**FAQ Number** 07-0038 Revision 3

**FAQ Title** Lessons learned on Multiple Spurious Operations

Plant: Turkey Point

The purpose of this FAQ is to provide updates to NEI 04-02 to reflect lessons learned from pilot plant activities, NFPA 805 task force meetings, and NRC reviews and discussions on multiple spurious operations (MSOs) and their treatment during transition to NFPA 805.

**Figure XX – Multiple Spurious Operations – Transition Resolution Process**

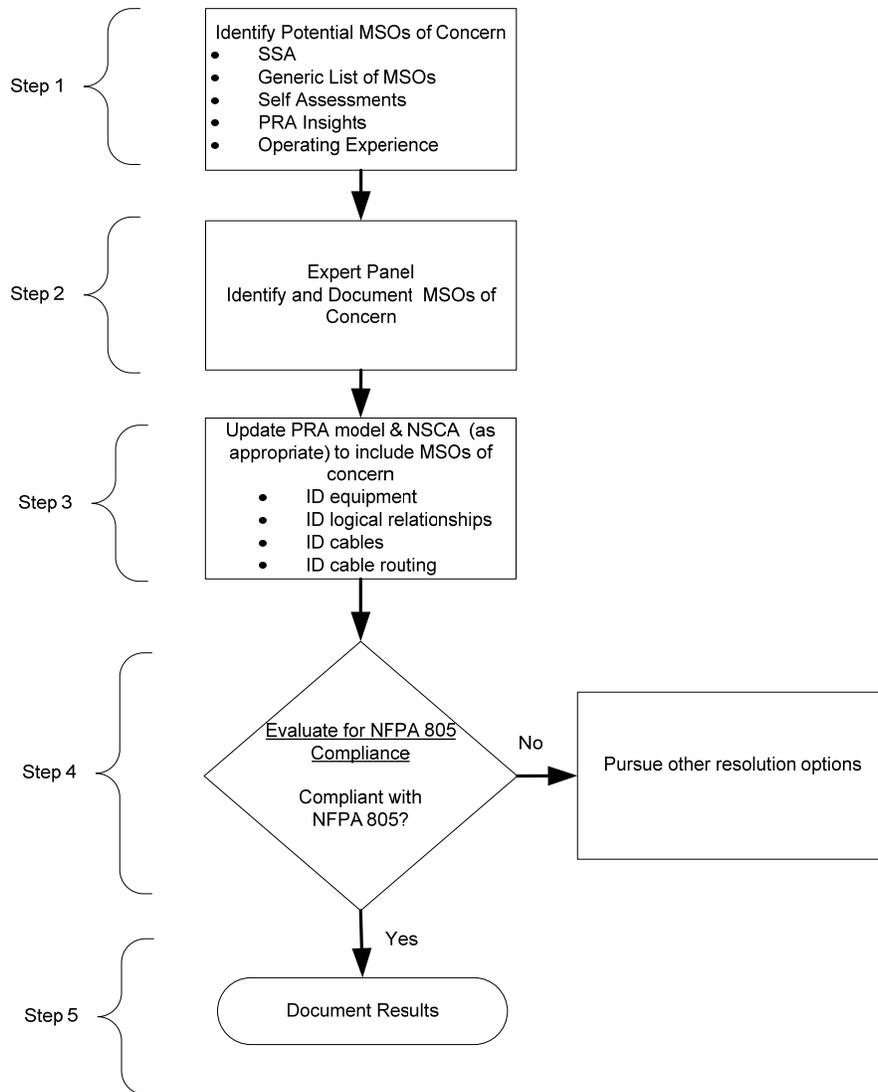
The approach outlined in Figure XX below is one acceptable method to address fire-induced MSOs. This method uses insights from a Fire PRA that meets the requirements of Regulatory Guide 1.205, Revision 1.

This process is intended to be in support of transition to a new licensing basis. Post-transition changes would use the risk-informed, performance-based change process. The post-transition change process for the assessment of a specific MSO would be a simplified version of this process, and may not need the level of detail shown in the following section (e.g., An expert panel may not be necessary to identify and assess a new potential MSO. Identification of new potential MSOs may be treated as part of the plant's Operating Experience process.
